**Rezoning Application:** PD 22-1640

**Hillsborough County Florida**

**Development Services Department**

**1.0 APPLICATION SUMMARY**

NEW RETAIL AREA PLAN

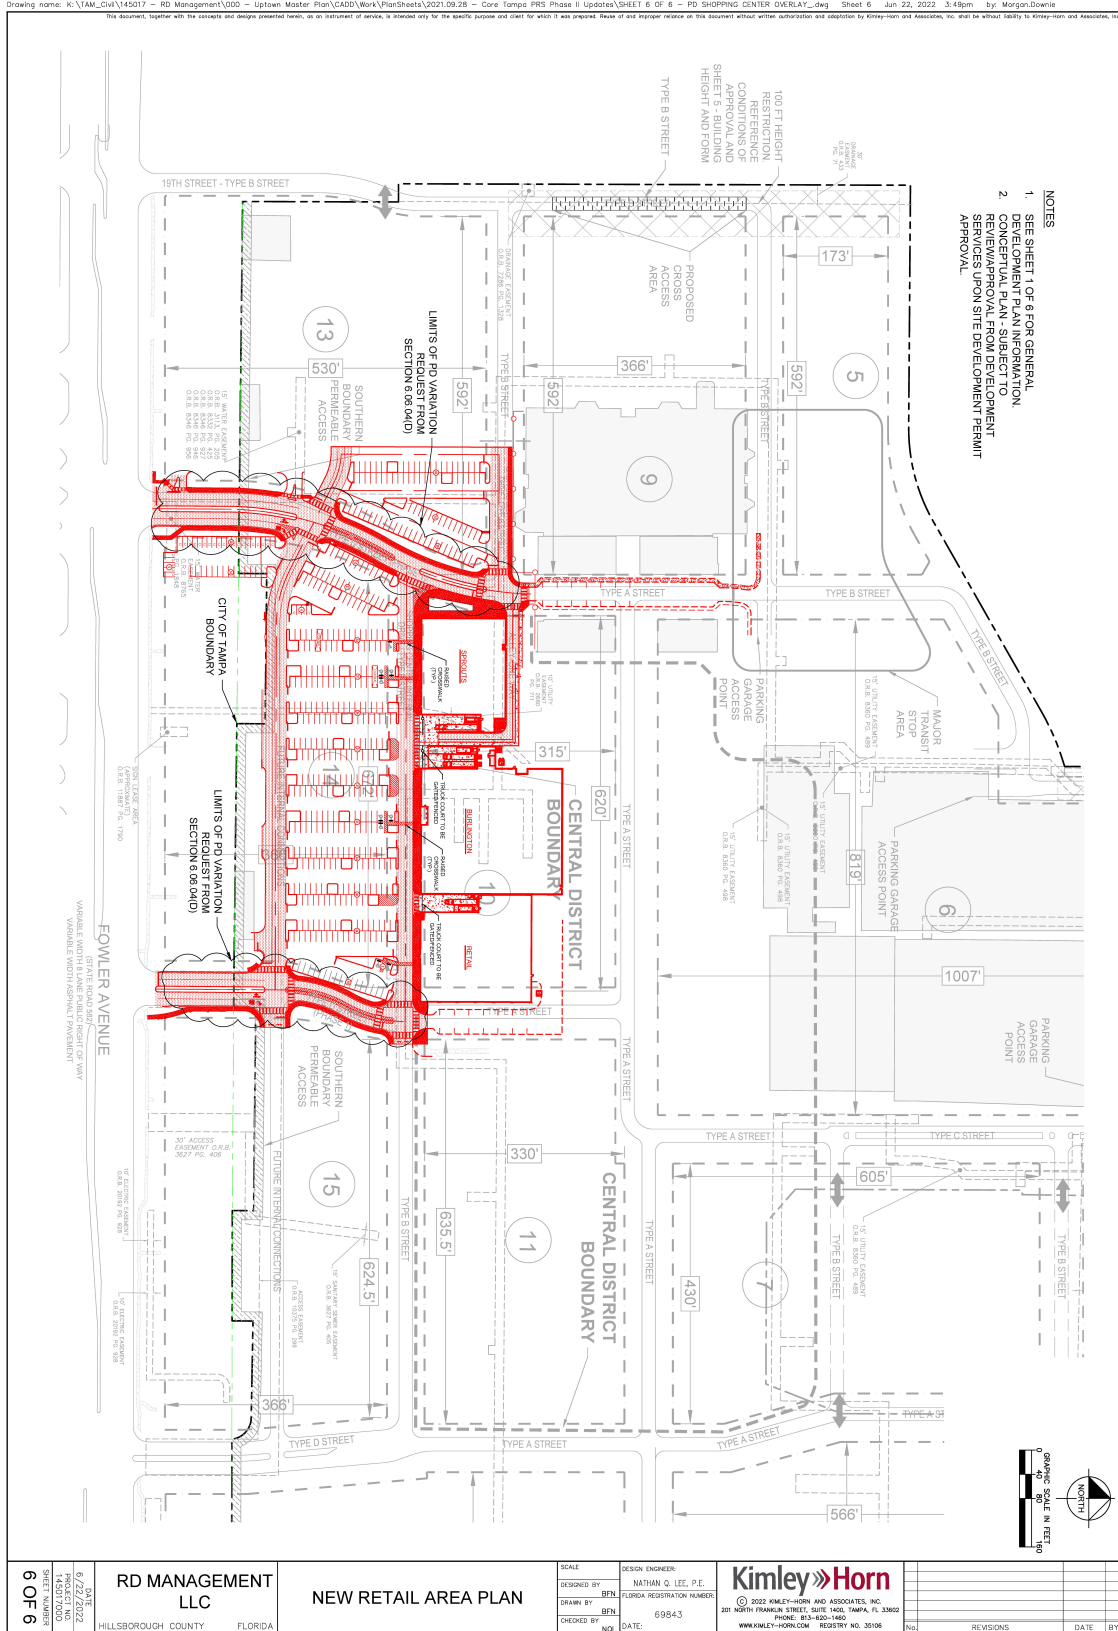
- 5.21 Notwithstanding any other provision of condition 5 to the contrary, the New Retail Area depicted on PD General Site Plan Sheet 6 of 6 may be developed with the Shopping Center Internal Drive Typical Section (not a Type B Street) and surface parking lot as shown on PD General Site Plan Sheets 2 of 6 and 6 of 6. Notwithstanding the above, at such time as any of the following occurs the developer shall complete the specified action:

- 5.22 Truck courts/loading areas abutting the Shopping Center Internal Drive shall be gated. The gates shall remain closed at all times, except during loading/truck deliveries. Placement of the gates shall be as shown on Sheet 6 of 6. Notwithstanding the above, truck courts/gates shall not be permitted in locations that interfere with any required alleyway stop signs and/or the required alleyway sidewalk connections. Nothing herein this condition shall be construed to mean that the alleyways cannot also be gated at both ends (regardless of anything shown on the PD site plan to the contrary) provided ungated pedestrian access is maintained).

12. The Vehicular Use Area (VUA) buffer shall be permitted to be reduced or eliminated in those areas marked as VUA Variation Area on sheet 6 of 6 of the GSP. At such time that Type D Phase 1 typical sections are replaced with the Type D typical sections, the required VUA areas shall be provided in accordance with LDC Sec. 6.06.04.
